Item Name: Baggage Compartment Protector - Wall

DART SERVICE INSTRUCTION

TO AMEND INSTALLATION INSTRUCTIONS IIN-D407-781-2 REV. A OR LATER APPROVED REVISION
AND INSTRUCTIONS FOR CONTINUED AIRWORTHINESS ICA-D407-781 REV. 3 OR LATER REVISION

In some aircraft, the top portion of the D206-781-041 Baggage Compartment Wall Protector Kit cannot be installed as indicated in IIN-D407-781-2. The purpose of this DSI is to provide an alternate mounting method to fasten the top portion of the D206-781-041 Baggage Compartment Wall Protector Kit.

FIGURE 1 - D3879-1 BAGGAGE COMPARTMENT WALL PROTECTOR - ALTERNATE INSTALLATION

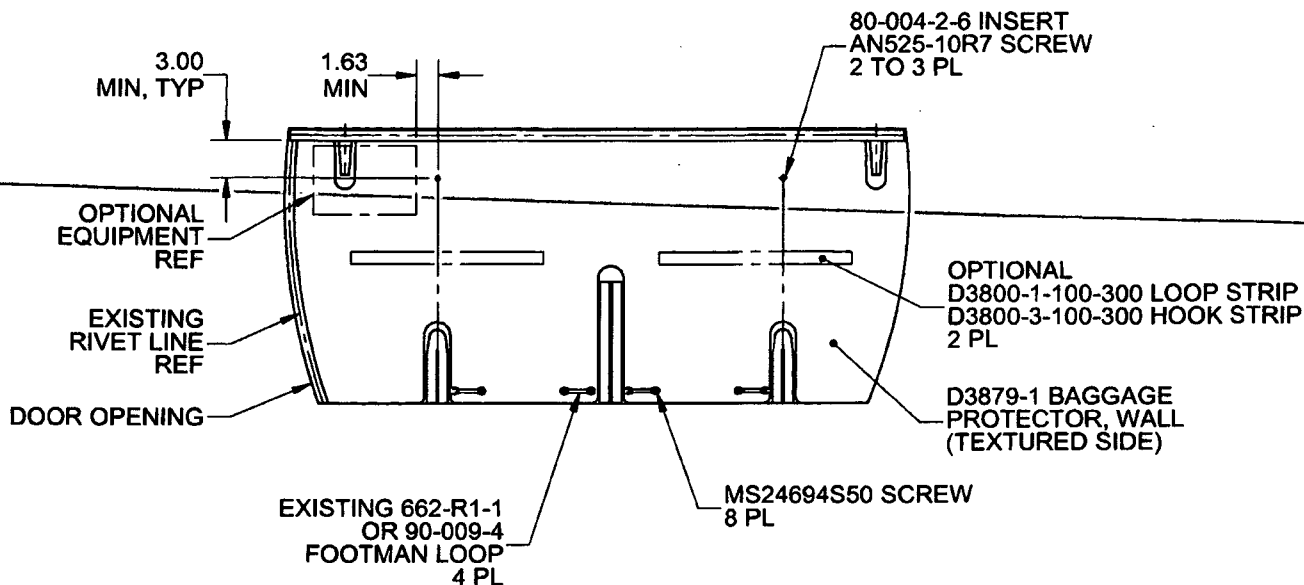
It is acceptable to replace qty(2) D3930-1 Clips with qty(2) 80-004-2-6 Inserts. Locate and mark location of the two attachment holes on the baggage compartment wall as shown in Figure 1 of this service instruction. Install 80-004-2-6 Inserts at the marked locations in accordance with Section 3-2-12 of BHT-206-SRM-1. It is acceptable to trim the wall protectors to accommodate optional equipment or transfer attachment holes to the wall protector and install the optional equipment on top of the wall protector with longer fasteners.

Amend the D206-781-041 Baggage Compartment Wall Protector Kit parts list as follows:

Qty -061	Qty -031	Qty -041	Part Number	Description
X			D206-781-061	BAGGAGE COMPARTMENT PROTECTOR KIT (FLOOR AND WALL)
1	X		D206-781-031	BAGGAGE COMPARTMENT FLOOR PROTECTOR KIT
1		X	D206-781-041	BAGGAGE COMPARTMENT WALL PROTECTOR KIT
		2	AN525-10R7	SCREW
		2	80-004-2-6	INSERT
